Title - Sujet Construction of New SAR MOB	
Solicitation No. - N° de l'invitation EB144-191545/A	Amendment No. - N° modif. 003
Client Reference No. - N° de référence du client EB144-19-1545	Date 2018-10-25
GETS Reference No. - N° de référence de SEAG PW-\$PWA-121-5794	
File No. - N° de dossier PWA-8-80050 (121)	CCC No./N° CCC - FMS No./N° VME
Solicitation Closes - L'invitation prend fin at - à 02:00 PM on - le 2018-10-30	Time Zone Fuseau horaire Atlantic Daylight Saving Time ADT
F.O.B. - F.A.B. Plant-Usine: <input type="checkbox"/> Destination: <input checked="" type="checkbox"/> Other-Autre: <input type="checkbox"/>	
Address Enquiries to: - Adresser toutes questions à: Russell (PWA), Alex	Buyer Id - Id de l'acheteur pwa121
Telephone No. - N° de téléphone (902) 401-8180 ()	FAX No. - N° de FAX (902) 496-5016
Destination - of Goods, Services, and Construction: Destination - des biens, services et construction:

Addendum No.2

Job Title: BIO SEARCH & RESCUE MARINA OPERATIONS BUILDING

Addendum No.3

1. Reference Drawing E-2 – Site Plan

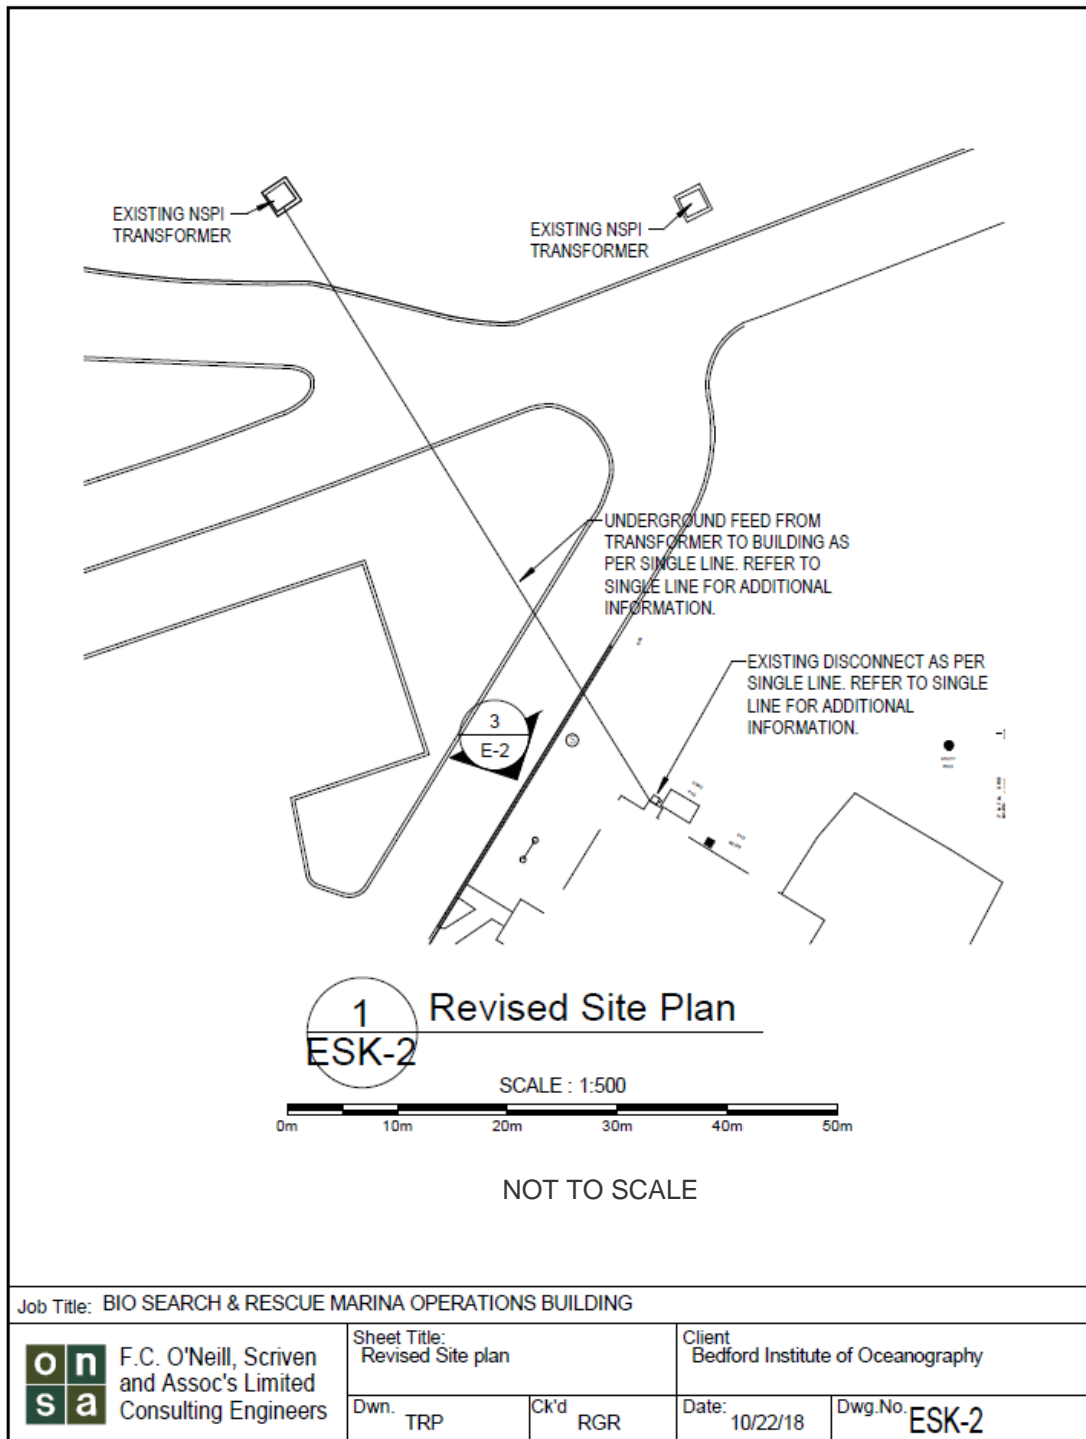
1. Underground feed from Argo building to existing NSPI transformer to be revised as noted in ESK-2 Revised Site Plan.
2. New fire alarm feed from Search and Rescue building to Holland building main fire alarm panel to be installed as indicated in ESK-3 Fire Alarm Feed.

2. Reference Drawing E-4 – Power & Communications Plans

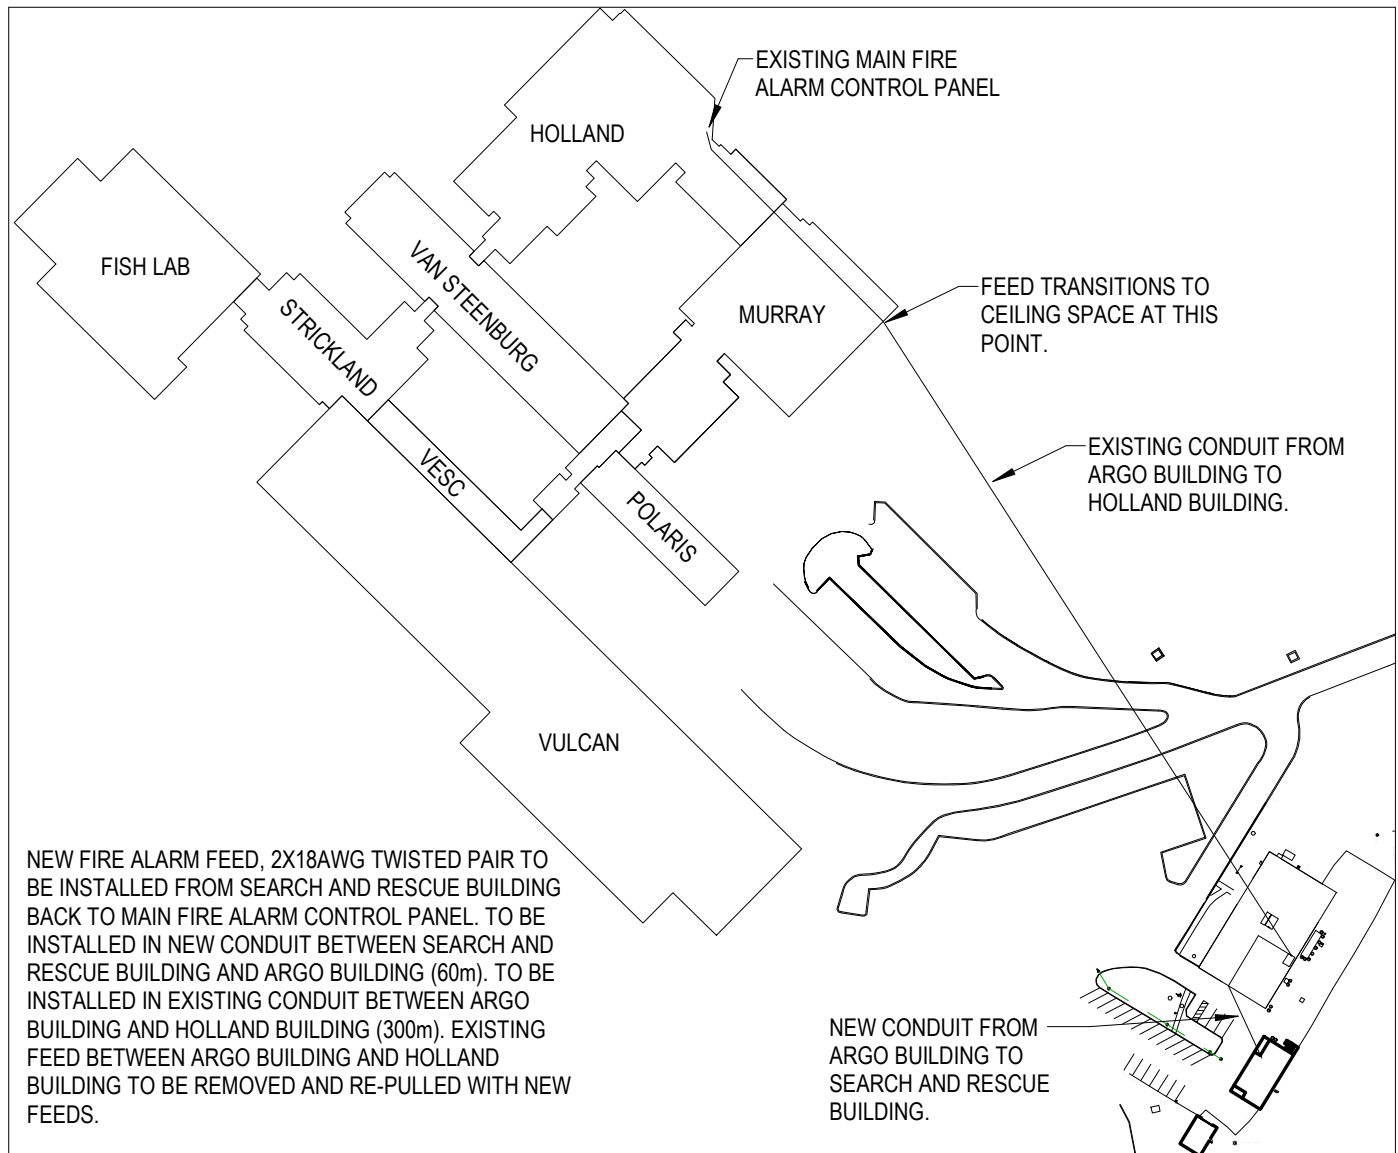
1. Data jacks to be revised in rooms 107 and 107 as noted in attached ESK-4 Additional Power & Data.
2. Dual duplex outlet circuited from 101-31 to be added to east wall of room 106 as noted in attached ESK-4 Additional Power & Data.
3. 22mm conduit to be installed from office 107 to roof as noted in attached ESK-4 Additional Power & Data.
